CENTRAL COAST COUNCIL

DEVELOPMENT SUPPORT SPECIAL COMMITTEE

6.1 Residential (subdivision to create two lots and construction of a dwelling) – variation to lot size and dwelling density requirements, variation to front and side setback standards and use of overhead electricity at 88 Esplanade, Turners Beach – Application No. DA2018097

<i>DEVELOPMENT APPLICATION No.:</i>	DA2018097
<i>PROPOSAL:</i>	Residential (subdivision to create two lots and construction of a dwelling) – variation to lot size and dwelling density requirements, variation to front and side setback standards and use of overhead electricity
<i>APPLICANT:</i>	EnviroPlan
<i>LOCATION:</i>	88 Esplanade, Turners Beach
<i>ZONE:</i>	Low Density Residential
<i>PLANNING INSTRUMENT:</i>	<i>Central Coast Interim Planning Scheme 2013</i> (the Scheme)
<i>ADVERTISED:</i>	25 September 2019
<i>REPRESENTATIONS EXPIRY DATE:</i>	9 October 2019
<i>REPRESENTATIONS RECEIVED:</i>	Three
<i>42-DAY EXPIRY DATE:</i>	1 November 2019
<i>DECISION DUE:</i>	28 October 2019
<i>PURPOSE</i>

DRAWN BY
 M Wells
 DESCRIPTION
 Site Plan

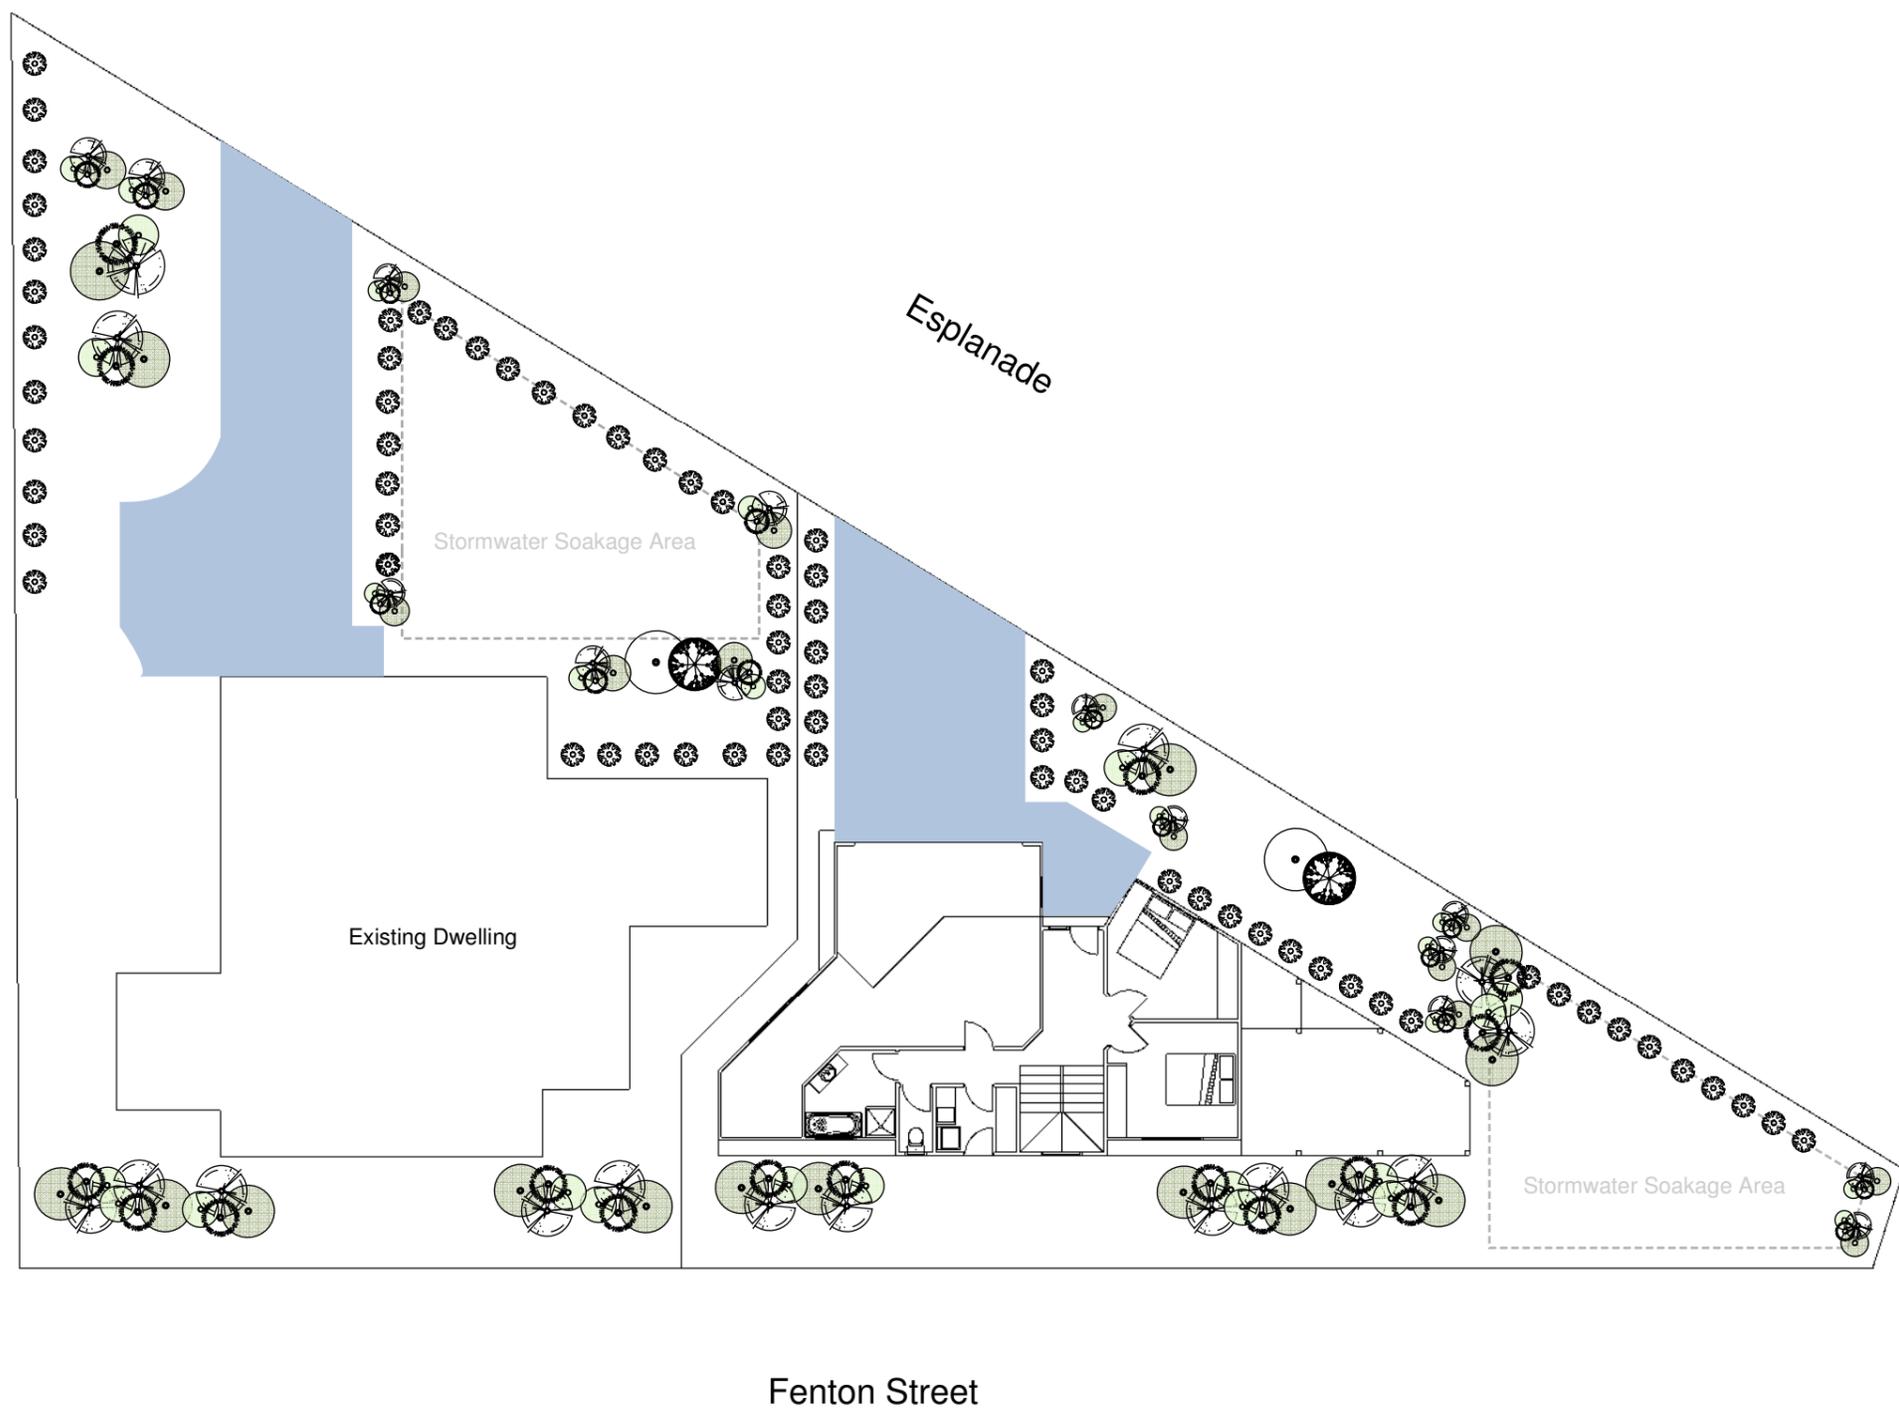
Plan 03 by EnviroPlan shows the on-site stormwater disposal area for both the existing and proposed dwelling. Each site has ample area for on-site stormwater disposal clear of buildings and access areas.

As per Plan 03 by EnviroPlan, Lot 1 has ample area for on-site stormwater disposal clear of buildings and access areas.

Lot 2 is also shown to have ample area for on-site stormwater disposal clear of buildings and access areas. The application includes the proposal for a single dwelling on Lot 2. This demonstrates that the site is capable to accommodate residential use in the form of a two-storey dwelling. Lot 2 would be accessed via a new crossover from Esplanade as per requirements set out in the Statement of Compliance issued by the Road Authority. The proposed dwelling would be consistent with the existing characteristics of the surrounding land which are all developed with both one-storey and two-storey dwellings, with many along the Esplanade similar in style, size and shape of the proposed dwelling on Lot 2. Both Lot 1 and Lot 2 are connected to a reticulated water and sewer system.

Please note that the stormwater from the existing development on 88 Esplanade goes to in-ground absorptions, as per attached plan.

You will need to provide an acceptable solution to stormwater disposal for the proposed lot and dwelling.

The revised proposal plan on page a03 demonstrates stormwater soakage areas for both allotments. The existing soakage area for the existing dwelling will be moved and located within lot 1.

DRAWN BY
 M Wells
 DESCRIPTION
 Landscaping Plan

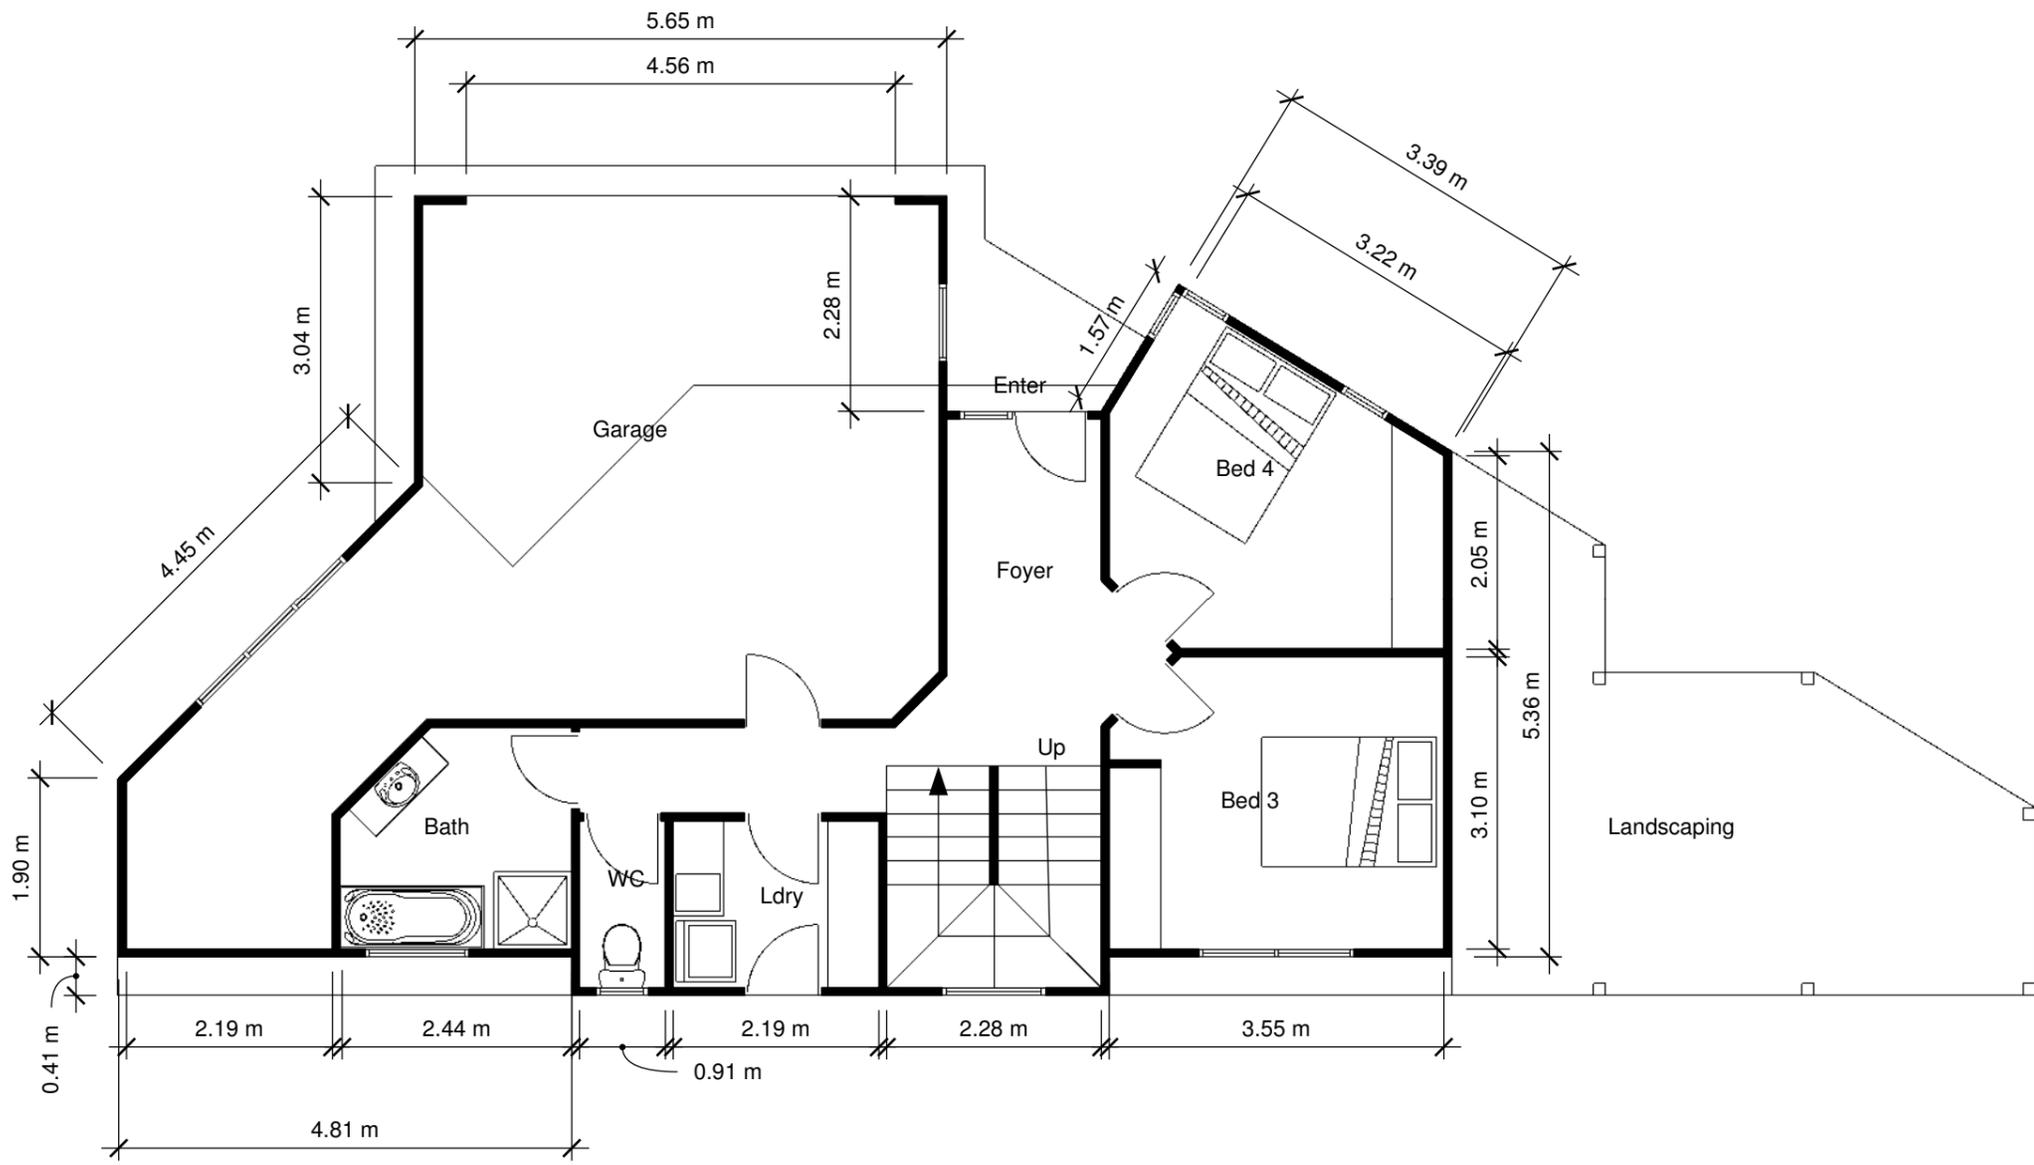
- *The Turners Beach Specific Area Plan requires that not less than 50% of the site area between the frontages and a building containing a dwelling must be landscaped with not less than grass.*

Would you please provide a revised landscaping plan illustrating this.

The revised proposal plans has a revised landscaping plan that accompanies the application.

DRAWN BY
M Wells
DESCRIPTION
Shadow Plans Winter

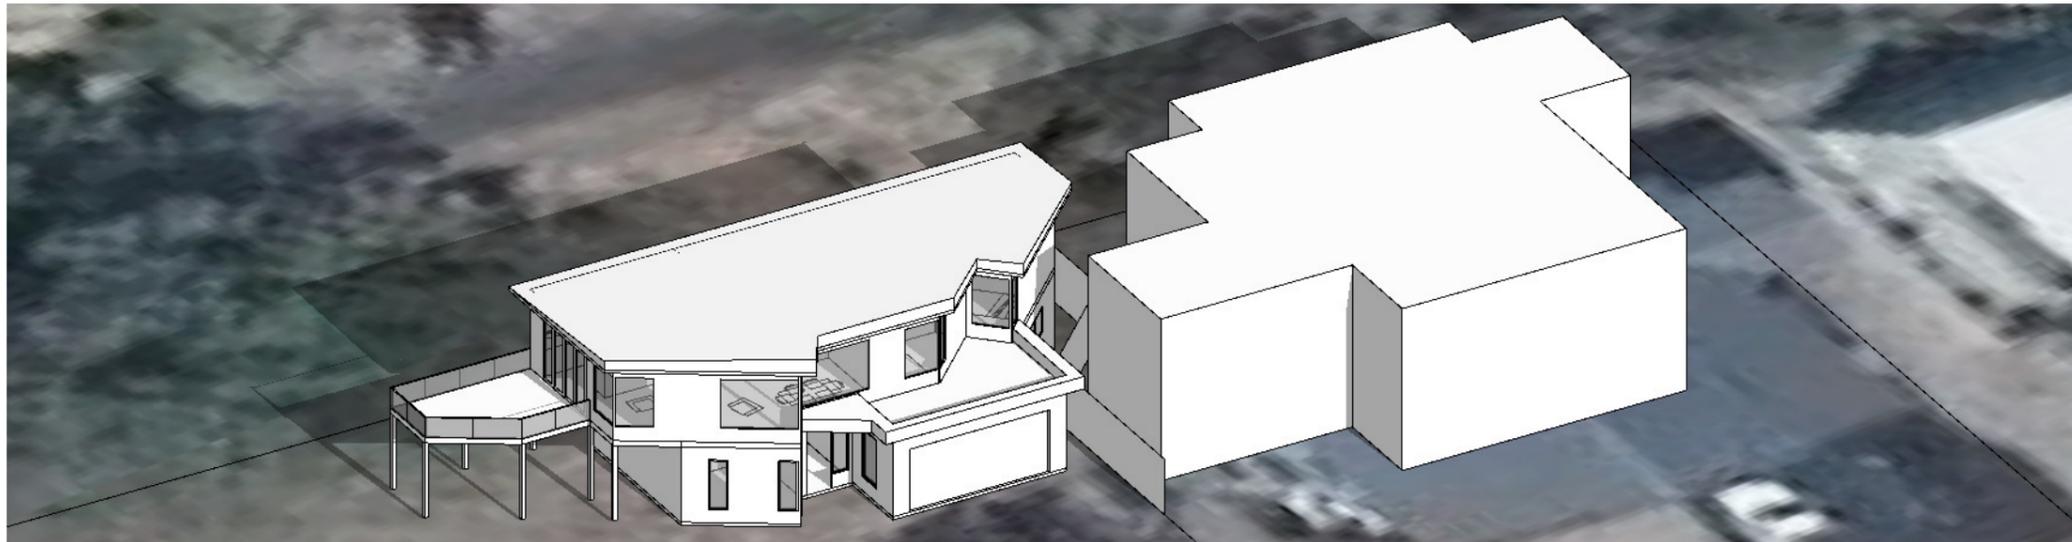
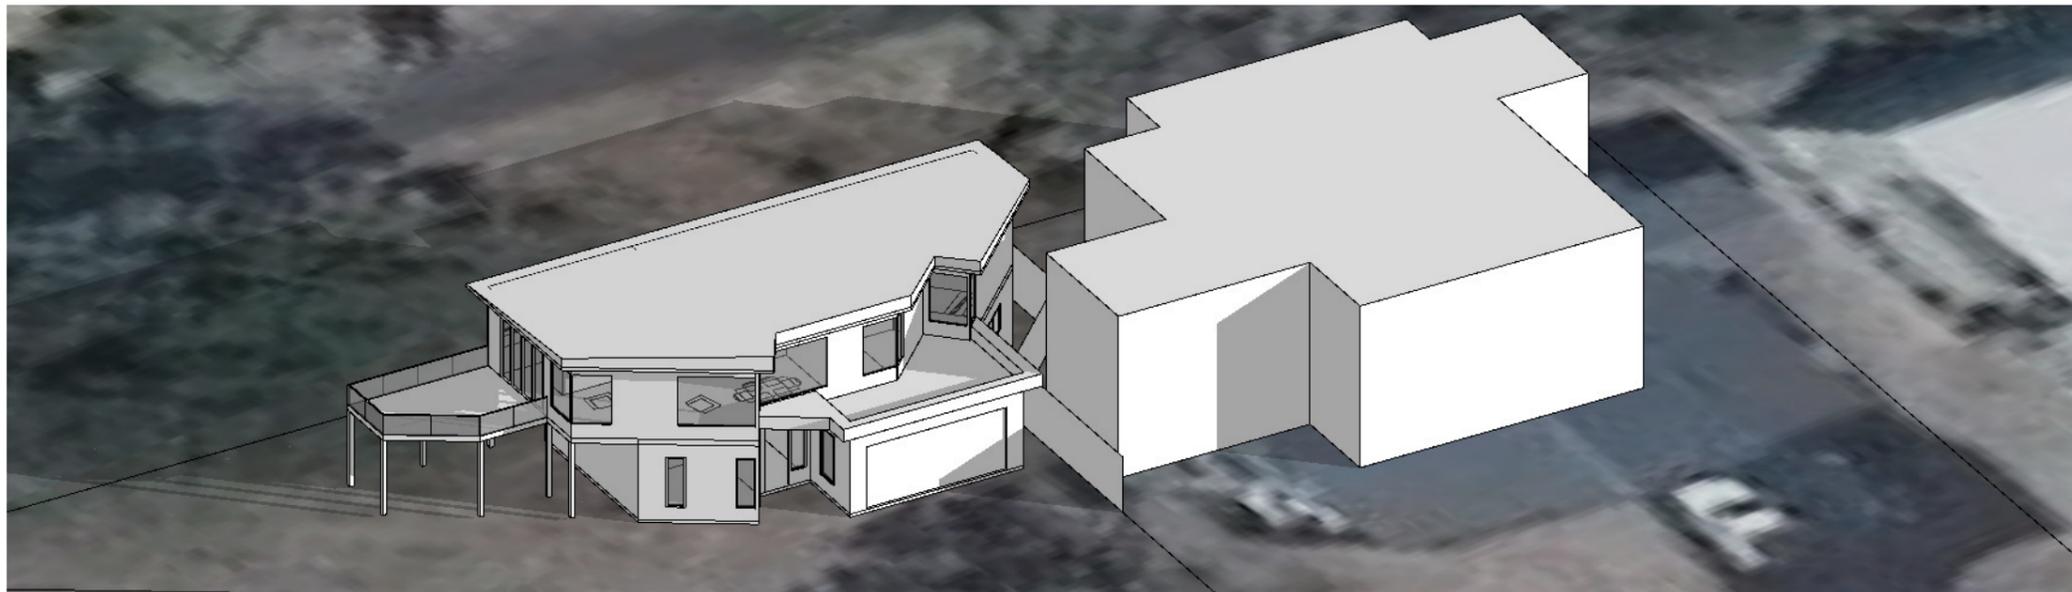
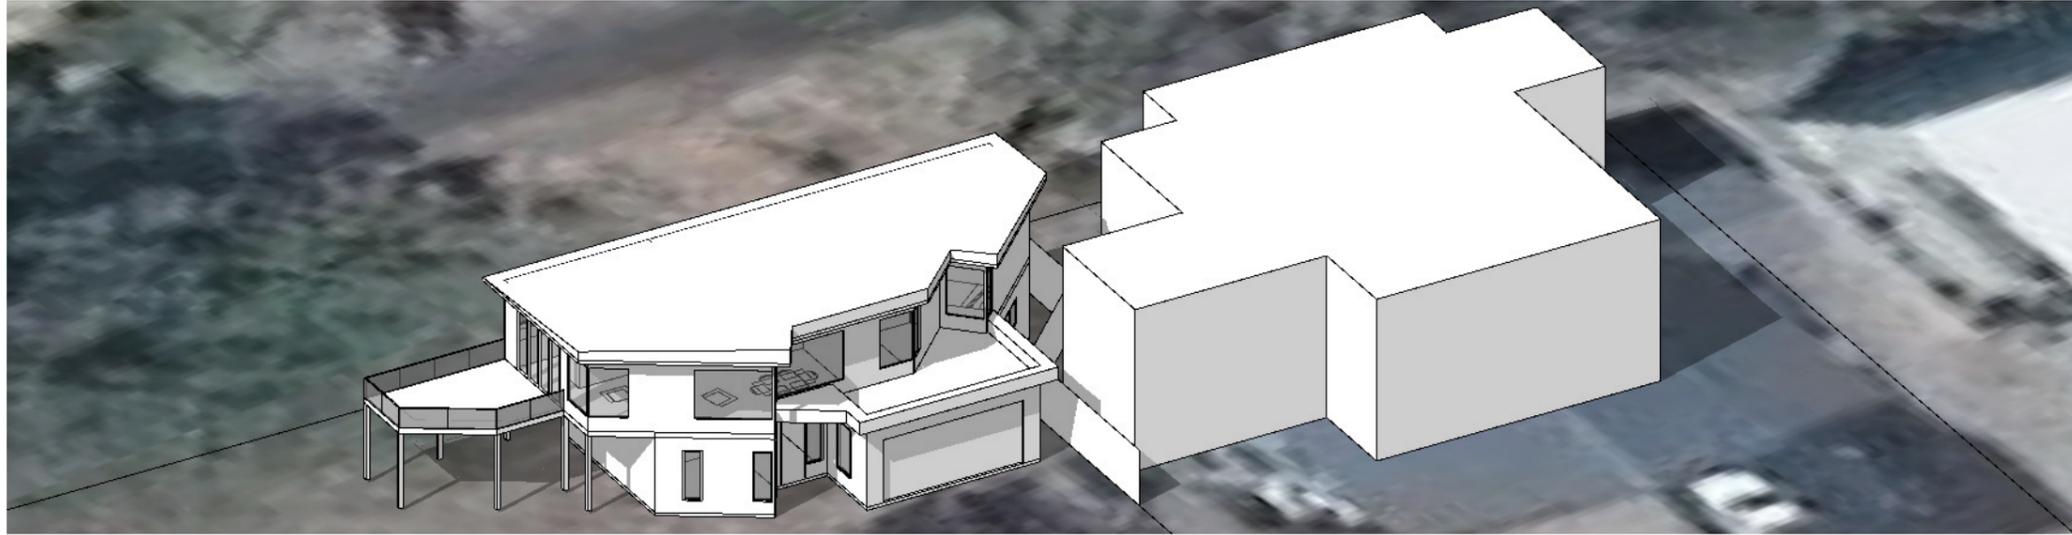
Shadow Plan 08 (21 June) shows that any shadow from the proposed dwelling would not unreasonably impact any adjoining habitable room and/or area for private open space. The Shadow Plan shows shadow that would occur behind the proposed dwelling across the southern portion of the site and clear of any adjoining properties along Fenton Street. The Shadow Plans show some shadow that would be cast into both Lot 1 and Lot 2 private open space, however that is from each dwelling located on the lot respectively. Each lot still has ample area for private open space that would not be unreasonably shadowed.
